ALBANY, OREGON
 WATER FILTRATION PLANT
 CHEMICAL BUILDING
 5000 GAL. LIQUID ALUM TANK
 PACIFIC POWER & LIGHT COMPANY
 PORTLAND, OREGON

ALBANY, OREGON
 WATER FILTRATION PLANT
 CHEMICAL BUILDING
 PACIFIC POWER & LIGHT COMPANY
 PORTLAND, OREGON

ALUM TANK PIPING DETAILS SECTION U-U SCALE 1"=1'-0"

SCALE: 1/4" = 1'-0"
 APPROVED *John L. Stiles* ENGR
 SHEET 16 OF 22 PE-19214

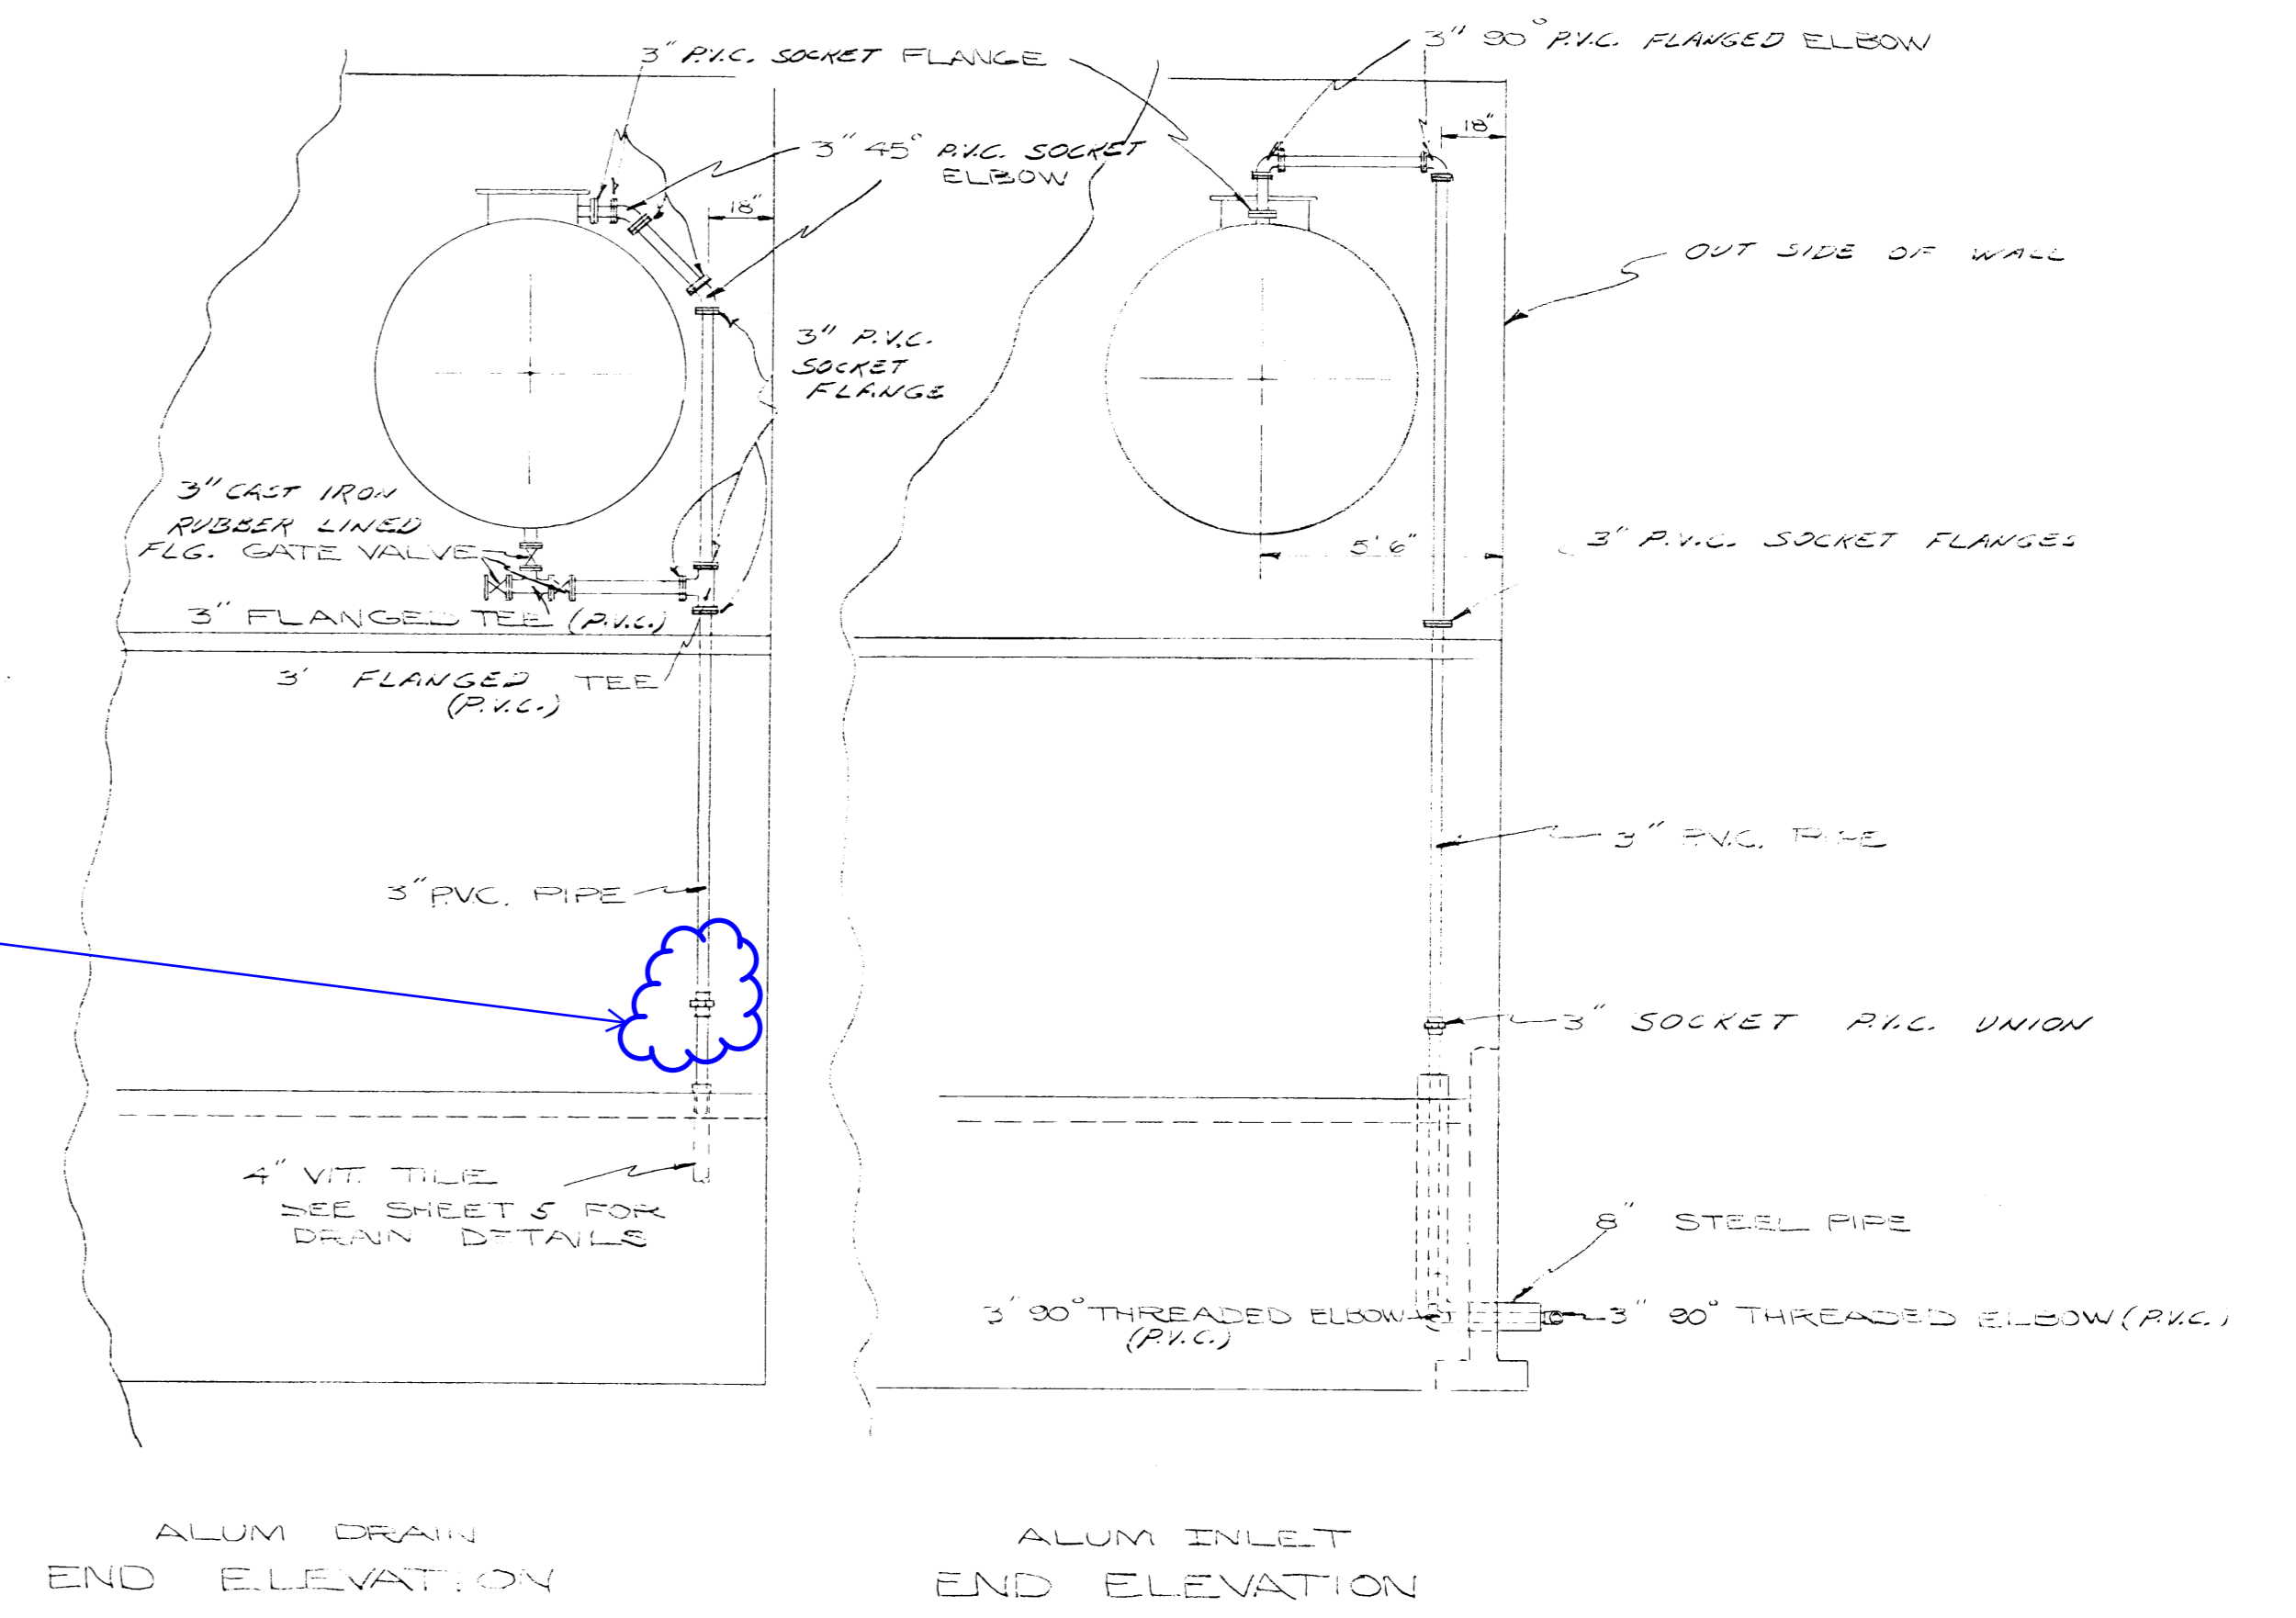
Union between water heaters where drain line could be opened to drain tank. However, I would prefer to drain the tank using the pipe that supplies the chem feed pumps. See next page.

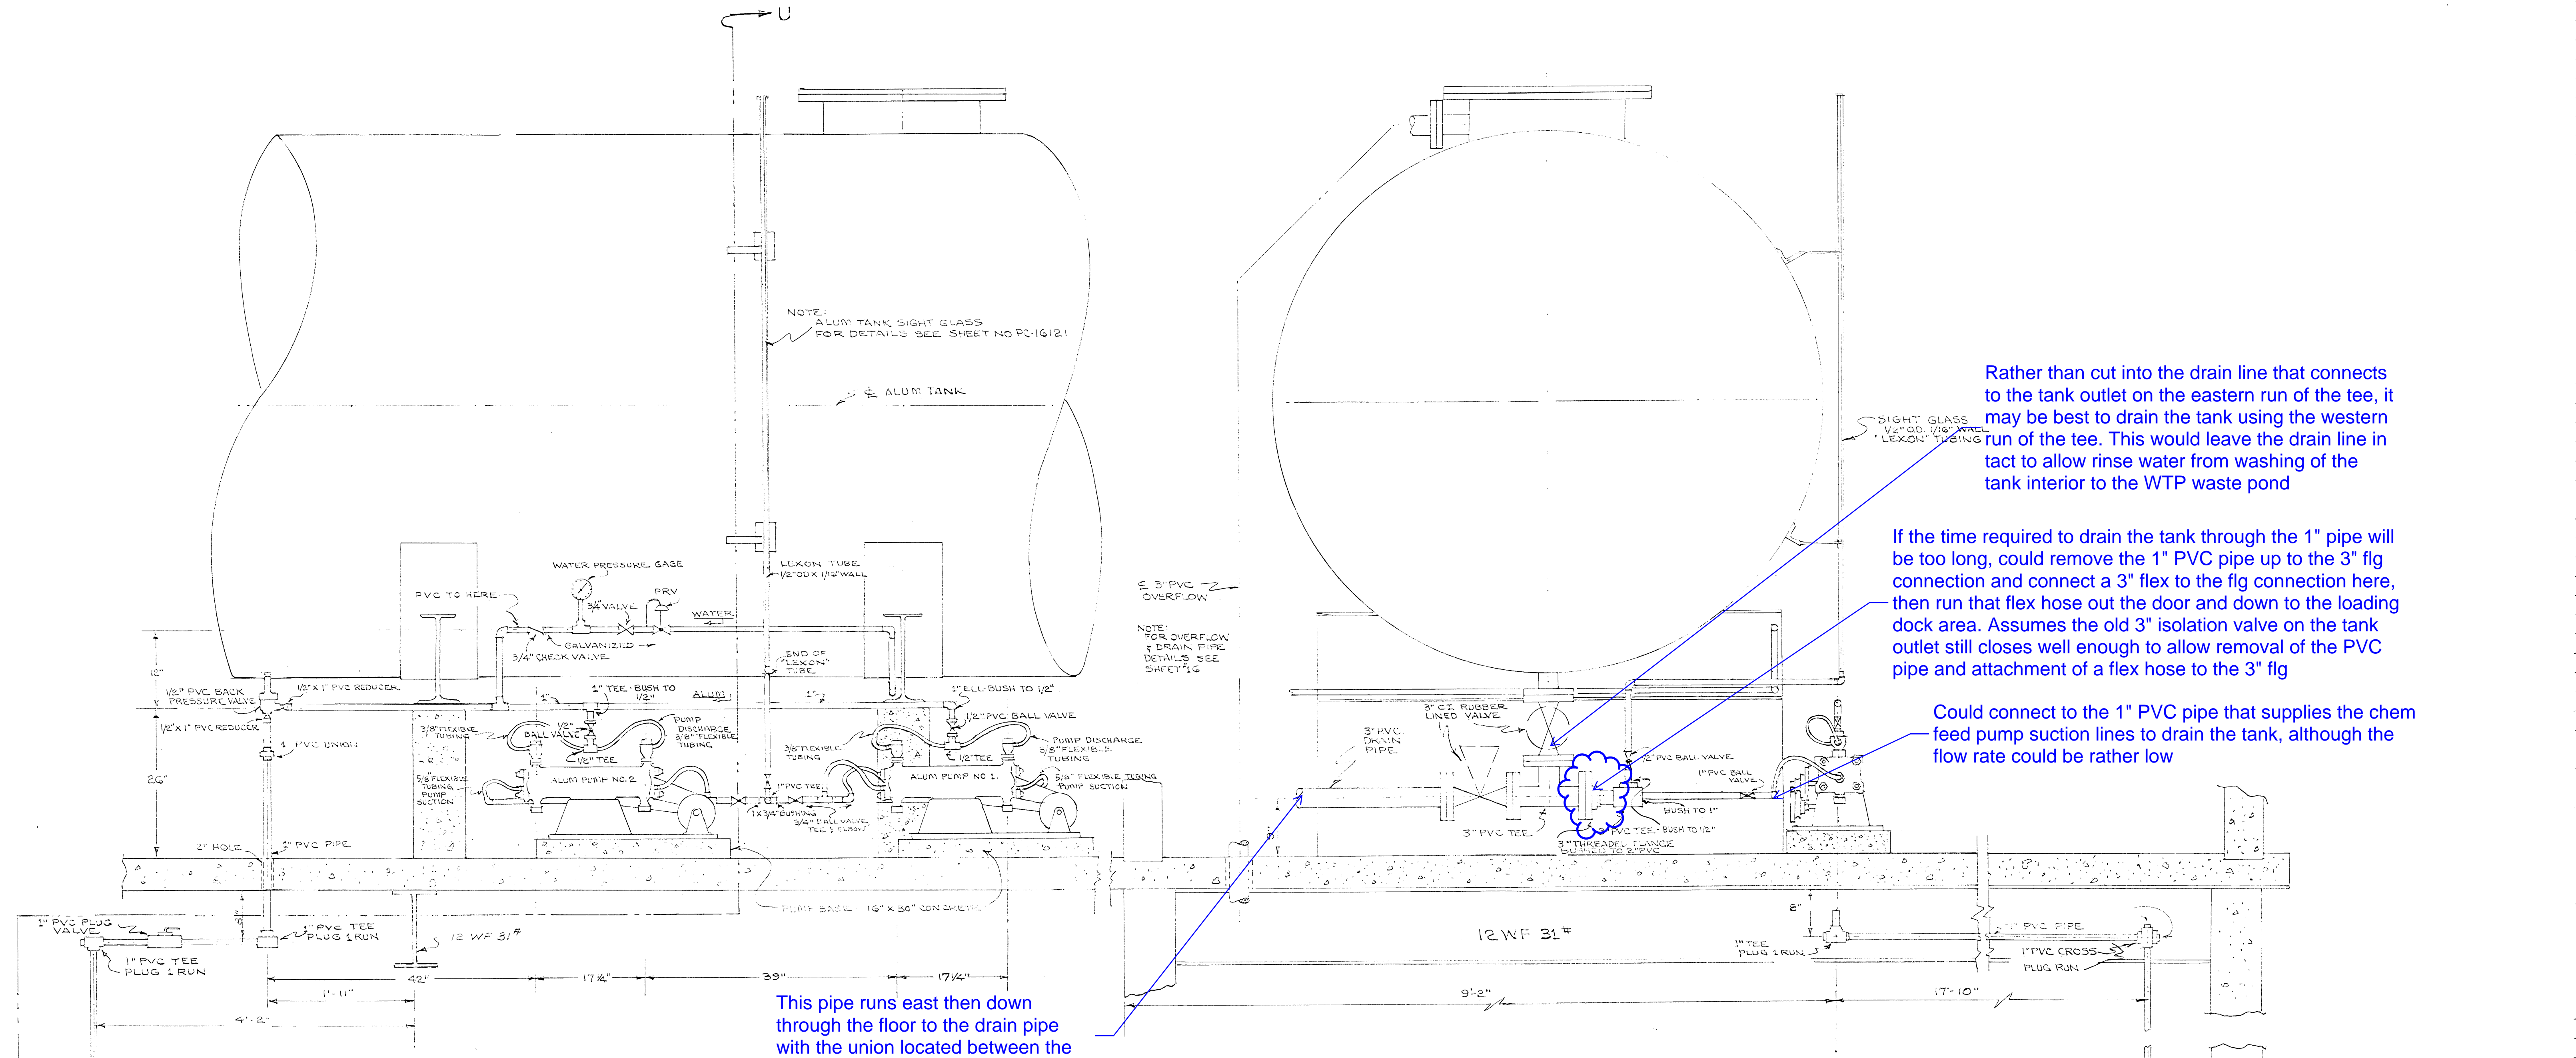
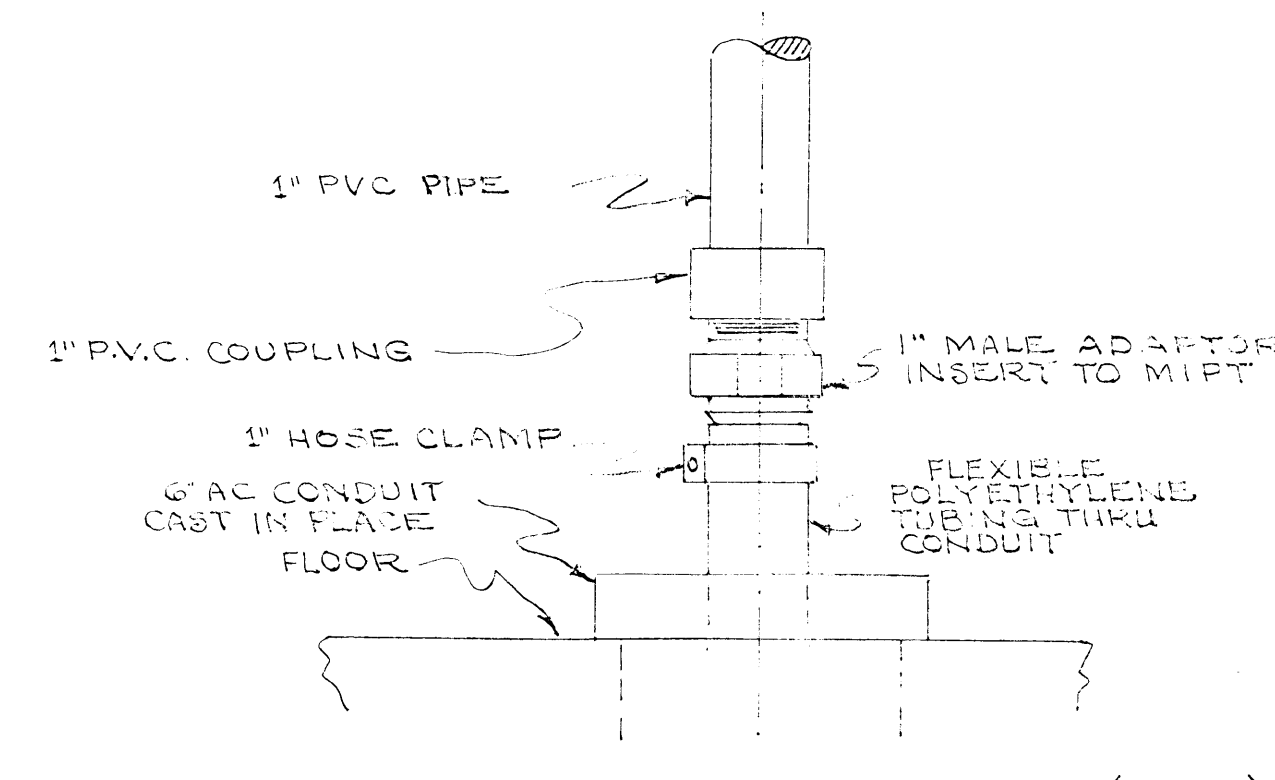
Rather than cut into the drain line that connects to the tank outlet on the eastern run of the tee, it may be best to drain the tank using the western run of the tee. This would leave the drain line intact to allow rinse water from washing of the tank interior to the WTP waste pond

If the time required to drain the tank through the 1" pipe will be too long, could remove the 1" PVC pipe up to the 3" flg connection and connect a 3" flex to the flg connection here, then run that flex hose out the door and down to the loading dock area. Assumes the old 3" isolation valve on the tank outlet still closes well enough to allow removal of the PVC pipe and attachment of a flex hose to the 3" flg

Could connect to the 1" PVC pipe that supplies the chem feed pump suction lines to drain the tank, although the flow rate could be rather low

This pipe runs east then down through the floor to the drain pipe with the union located between the two water heaters.
